STATE OF NORTH CAROLINA
DEPARTMENT OF TRANSPORTATION

February 16, 2006

Subject: **APPLICATION REVISION for Individual Section 404 and 401 permits for TIP R-2616** for the proposed widening of US 601 from the South Carolina State Line to north of Marion Lee Road (SR 2105) south of Monroe in Union County; NCDOT Division 10. Federal Project No. STP-NHS-601(4), State Project No. 8.1690303, WBS Element 34485.1.1.

**R-2616, US 601 Widening, Union County, Yadkin River Basin
(CU 03040105); Southern Piedmont (SP) Eco-Region**

Permit Application Plansheet Page 12

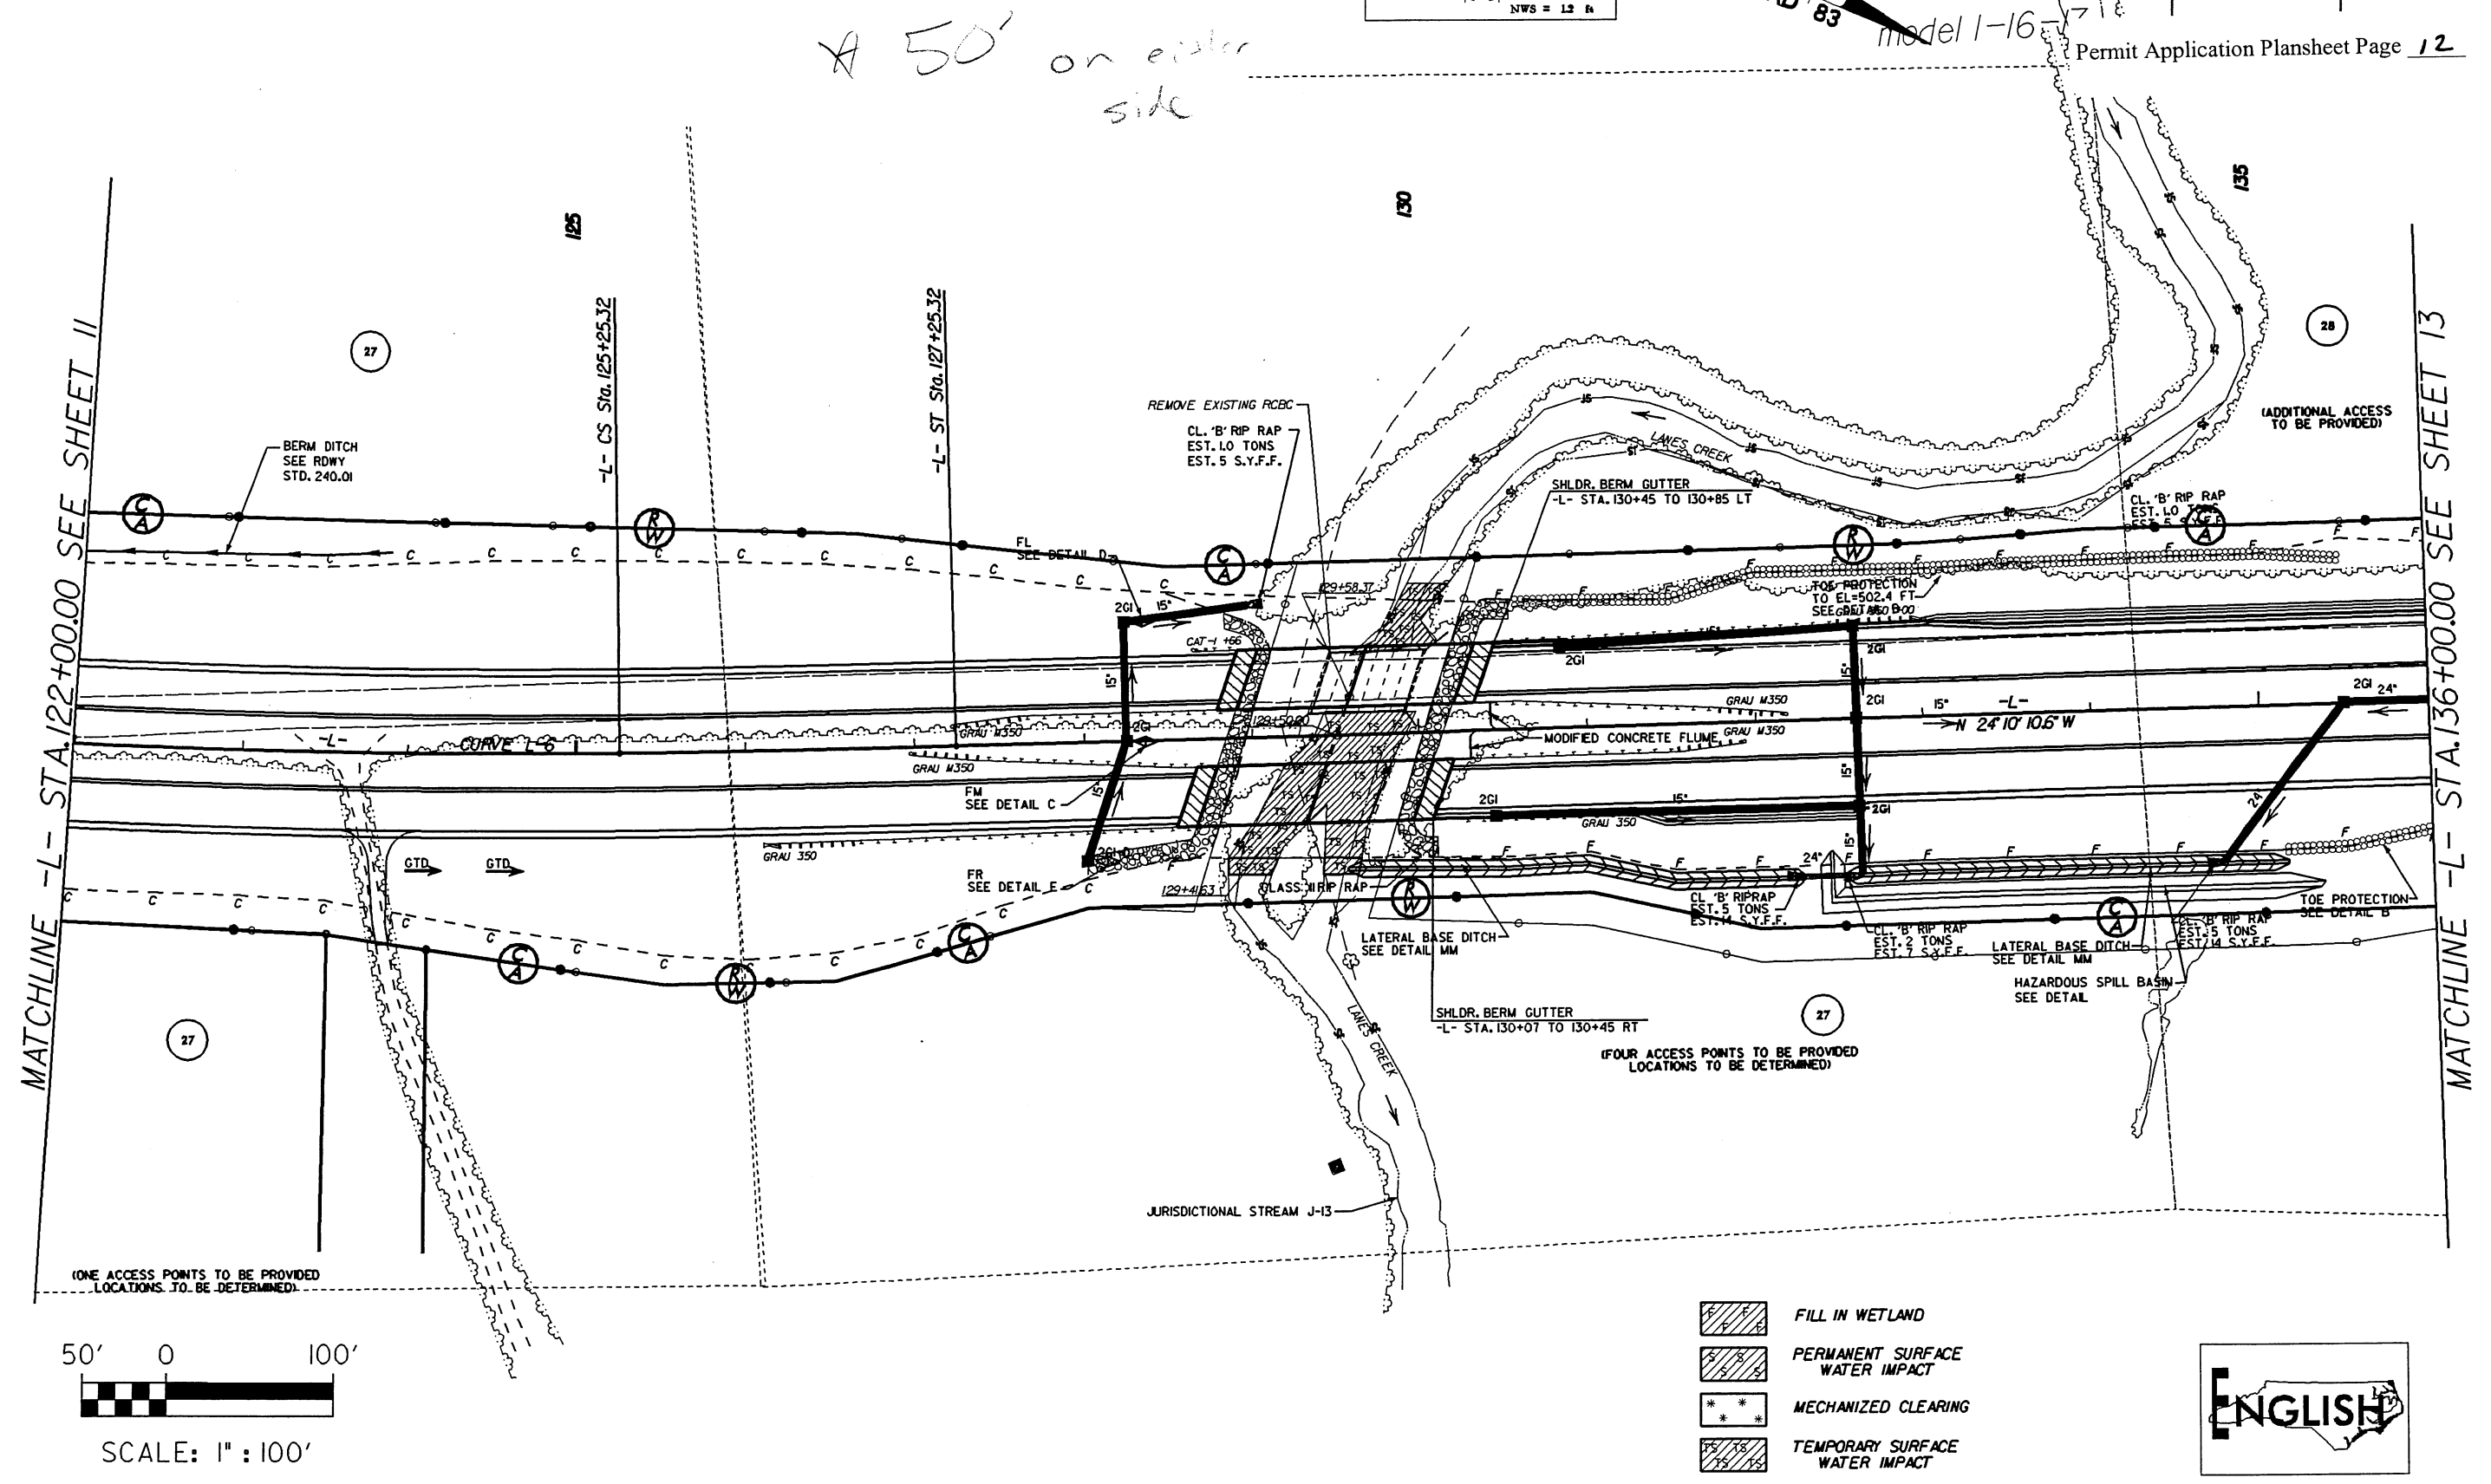
Site 3 (Permit application page 12): The current sextuple barrel box culvert will be removed and replaced with a bridge. We have subtracted 39 linear feet of permanent

stream impact from the total permanent stream impact for the project for using a spanning structure.

Permit Application Plansheet Page 18

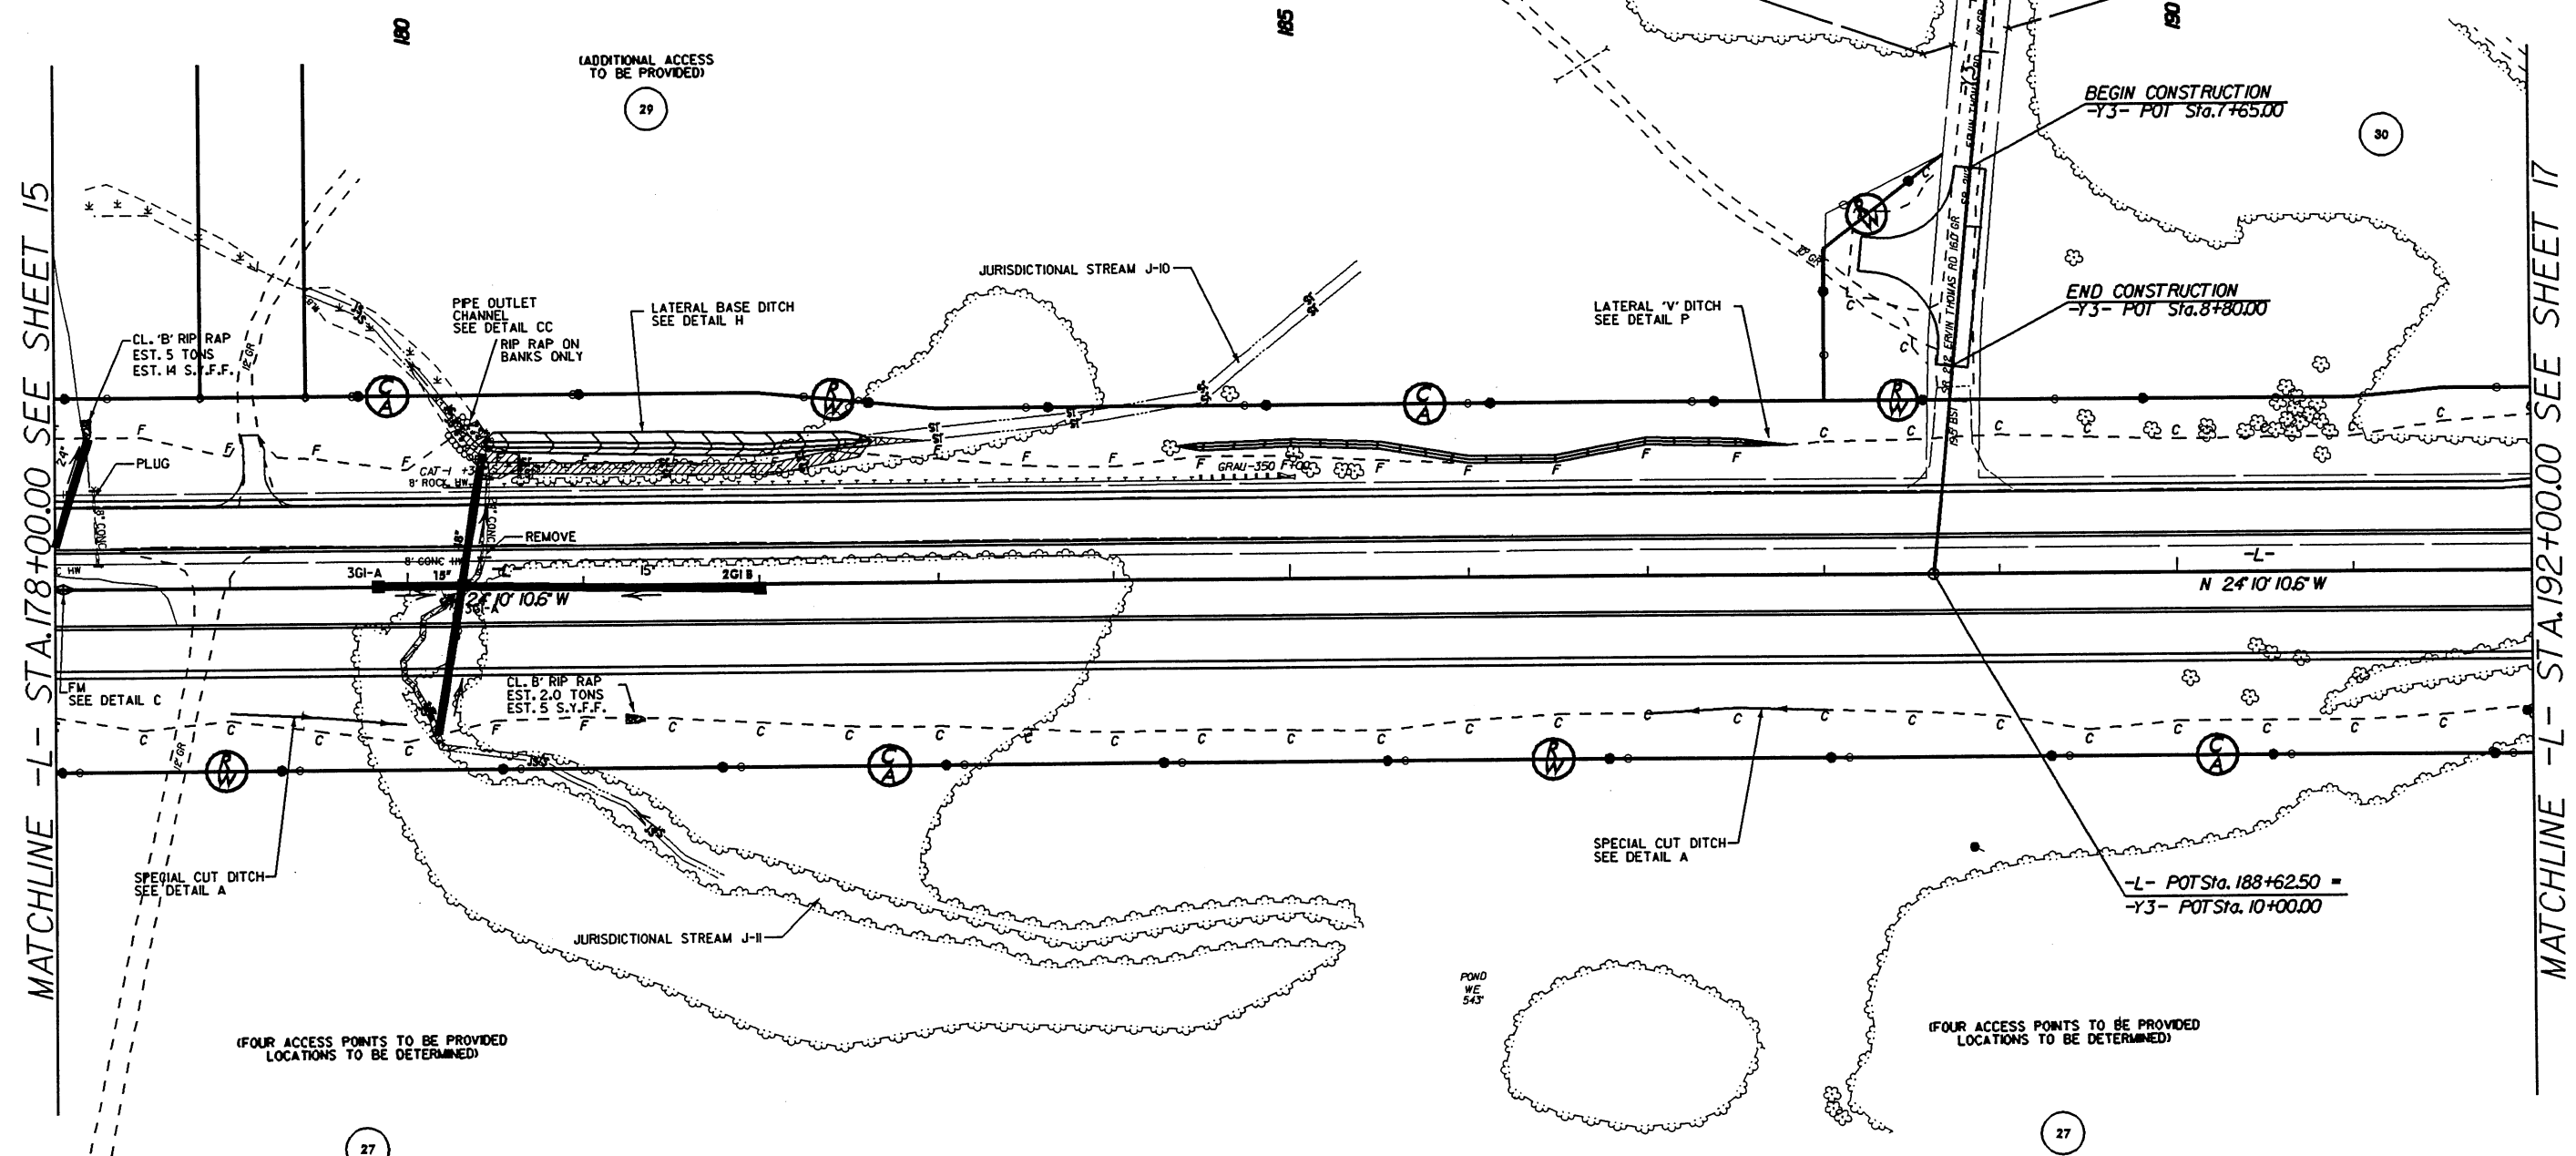
Sites 5 & 6 (Permit application page 18): On the previous impact summary table, the impacts for Sites 5 & 6 were separated into corresponding Left and Right sides of the road, and adjacent wetland impacts were shown with site 6. As the same stream is impacted on the Left and Right sides, the stream impacts have been combined into Site 5, and the wetland impacts are shown solely with Site 6.

The permanent impacts to wetlands have decreased by 0.0011 acre (from 0.015 to 0.004).

The temporary stream impacts have increased by 27 feet (from 11' to 38') due to the temporary de-watering activities for the installation of the box culvert.

Site 7 (Permit application page 18): The permanent stream impacts have increased by 23 feet (from 192' to 215') due to a calculation error.

Permit Application Plansheet Page 49

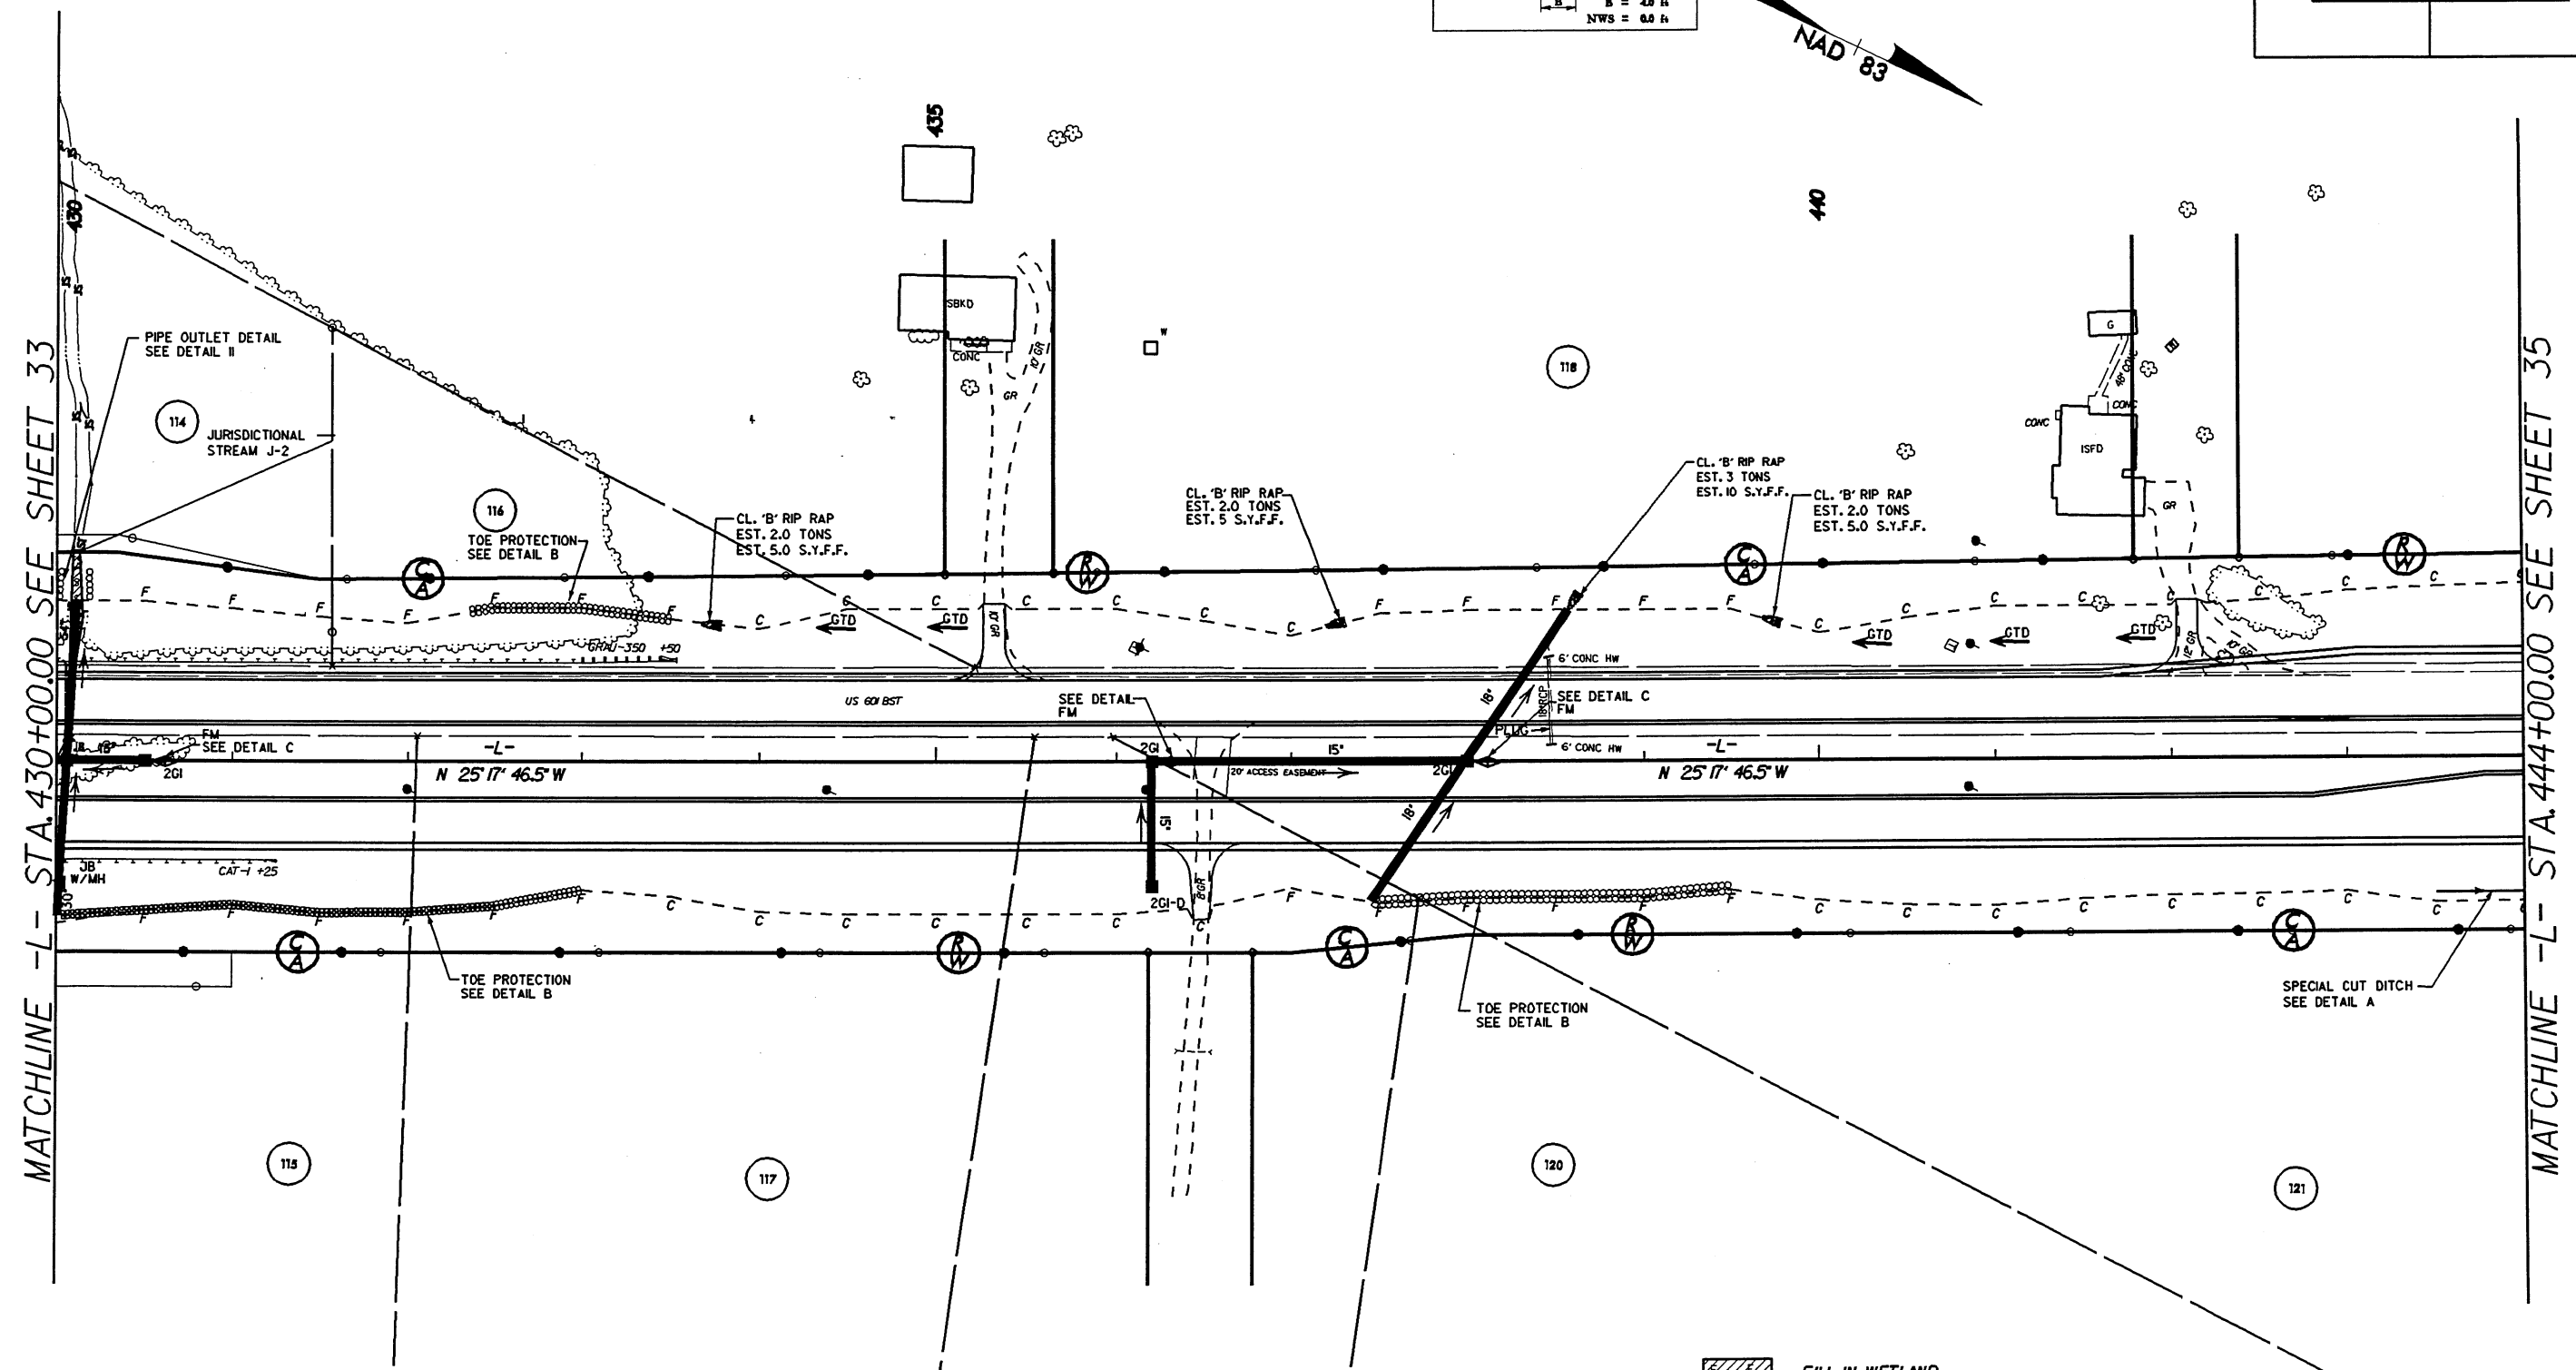
Site 22 (Permit application page 49): The permanent stream impacts have increased by 14 feet (from 446' to 460') and temporary impacts have increased by 10 feet (from 20' to 30') due to a calculation error.
